June 7, 1984

NRC DOCKETS 50-321, 50-366
OPERATING LICENSES DPR-57, NPF-5
EDWIN I. HATCH NUCLEAR PLANT UNITS 1, 2
RESPONSE TO REQUEST FOR INFORMATION ON
SAFETY PARAMETER DISPLAY SYSTEM

In response to your letter dated April 23, 1984, Georgia Power Company (GPC) provides herein information related to installation of the Safety Parameter Display System (SPDS) at Plant Hatch. Your questions are restated, followed by the GPC response.

Figure 22
 Seismic Test Setup
 2A0-VAI Voltage-to-Current Converter

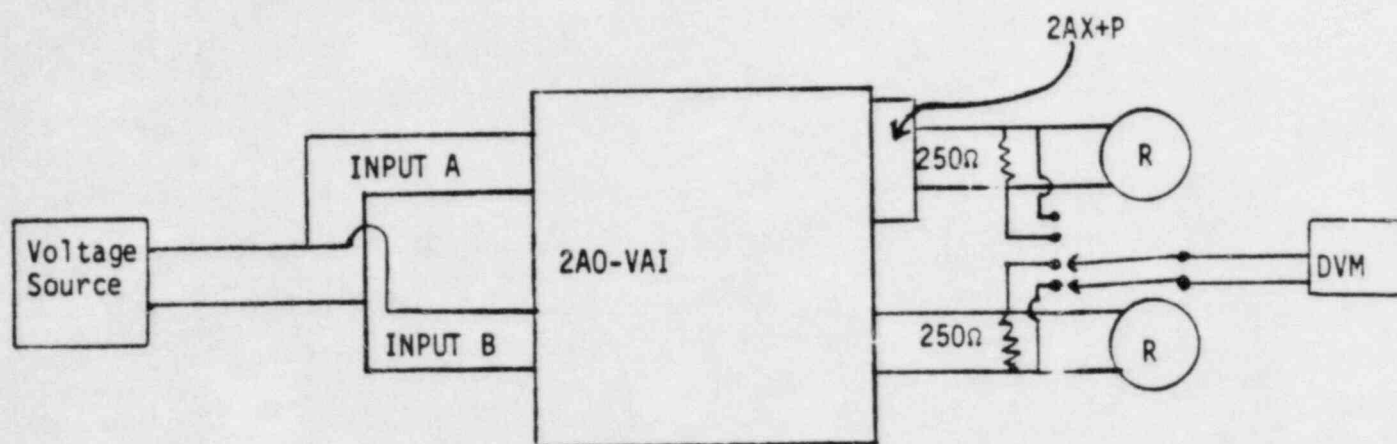
2.3.a For each type of device used to accomplish electrical isolation at Hatch 1 and 2, describe the specific testing performed to demonstrate that the device is acceptable for its applications(s). This description should include elementary diagrams where necessary to indicate the test configuration and how the maximum credible faults were applied to the devices."

The proposed method of electrical isolation of the SPDS from safety systems is by use of optical isolators qualified for Nuclear Class 1E safety related service.

The requested test results are provided in Foxboro documents Q0AAA20 and

Q0AAB44. Refer to Paragraph 5.4.2 and Figures 22, 31, 76, and 77 of attachment 1.
